PI Ref. SD21A/0051  
Our Ref: 17573 /RC/RH

**Re: Proposed Continuance of use of the 3 existing buildings and associated areas, RGR Holdings Limited: Wilsons Auctions, Green Isle Road, Corkage Dublin 22.**

Further to your request for further information dated 27<sup>th</sup> April 2021 I set down below my response to query No.6 and Query No.7.

F) Details of proposed retro-fit SuDS solution to rainwater management at Wilson Auction Premises is indicated on drawing No. 4996-02-P30.

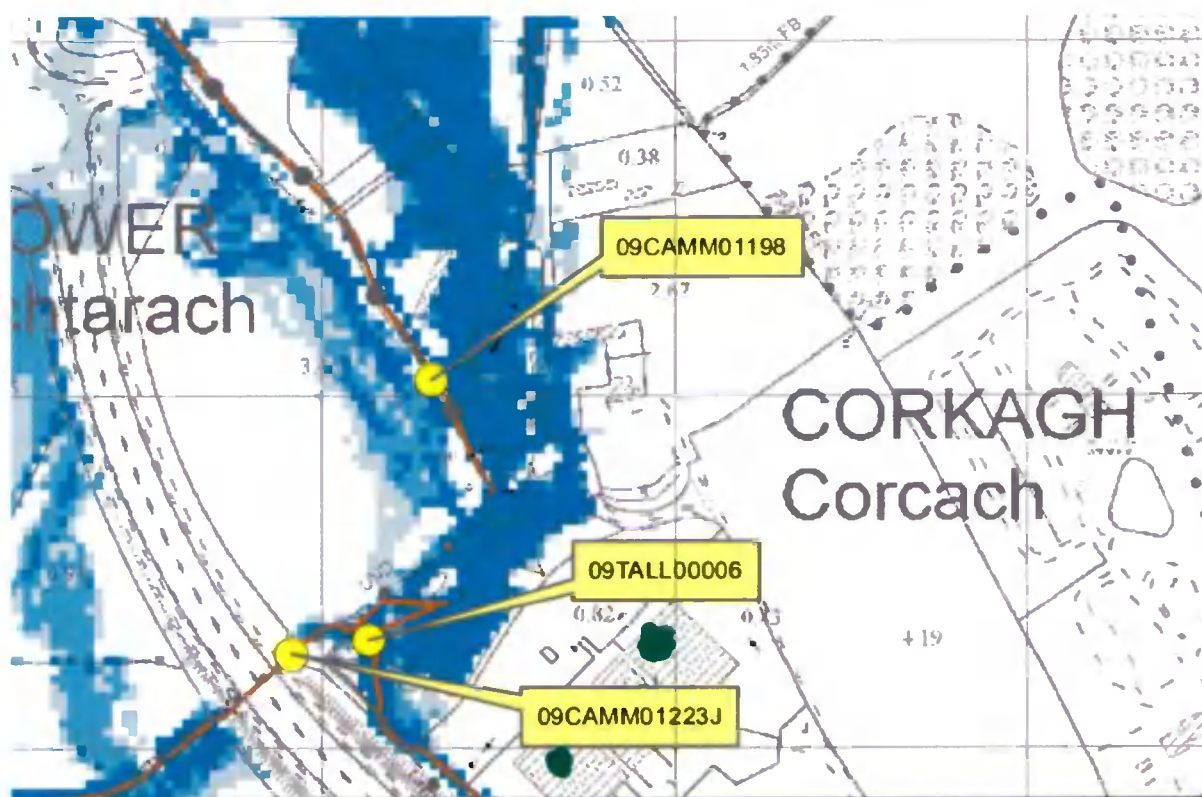
6. The applicant should note that based on the limited information provided, the surface water attenuation provided of 255m<sup>3</sup> for 1:30 year is estimated to be undersized by approximately 255%. The surface water attenuation of 407m<sup>3</sup> provided for 1 in 100 year storm is estimated to be undersized by approximately 60%. Both of which are considered to be unacceptable and contrary to the provisions of the County Development Plan. The applicant is requested to submit the following:

- (c) A report and revised plan proposals showing what SuDS (Sustainable Drainage System) are proposed for the development.
  - (d) A revised surface water/SuDS plan and method statement that introduces significant SuDS elements to the overall design, which should include the greening of all infrastructure on the site. Please note that over-engineered solutions will not be looked upon favourably and that SuDS features such as tree pits, green area detention basins, swales, green roofs, permeable paving rain gardens, channel rills and other such SuDS should be included within the revised proposals.

- (e) The applicant shall show what the surface water attenuation capacity in m<sup>3</sup> is for such SuDS.
  - (f) The applicant shall submit a revised drawing showing what surface water attenuation is proposed for the development. Include SuDS in surface water attenuation provided. Show what the capacity is for each surface water attenuation system is for the site.

D) The scheme and components that were chosen were derived from the site topography and the pre-development drainage patterns, which ensure two key overland flood routes through the site (Natural Flow Path) as indicated on drawing No. 4996-02-P30.

For design purposes this site is divided into three separate catchment drainage areas (Area A, Area B & Area C) none of which are interlinked. Refer to drawing No. 4996-02-P30.

To provide a 1 in 100 year return period volume with an extra 20% allowance for probable climate change the volume of storage required for catchment area B is 1,118m<sup>3</sup>.

The capacity of sourced local components is 162.5m<sup>3</sup> this reduces the underground storage to 955.5m<sup>3</sup>

The Stormwater attenuation system proposed is Storm Tech Chamber Model MC-4500, Installation storage capacity 978cum.
